#08-01-39-004: Rattle Noise From Right Front Area of Engine Compartment (Reposition A/C Line Away From Frame Rail) - (May 9, 2008)

Models: 2008 Saturn Astra

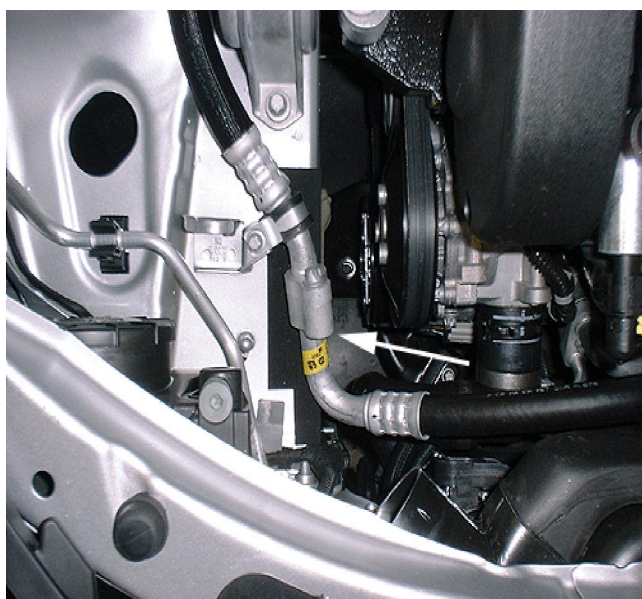
Some customers may comment on a rattle noise from the right front area of the engine compartment. Technicians may find the noise easier to hear inside the vehicle rather than outside the vehicle.

The low side Air Conditioning (A/C) line may contact the right front frame rail just below the air cleaner assembly.

Technicians are to reposition the A/C line to provide sufficient clearance away from the frame rail.
© 2019 General Motors Corporation. All rights reserved.

Refer to the illustration above, which shows the location of the A/C line contact point on the frame rail.
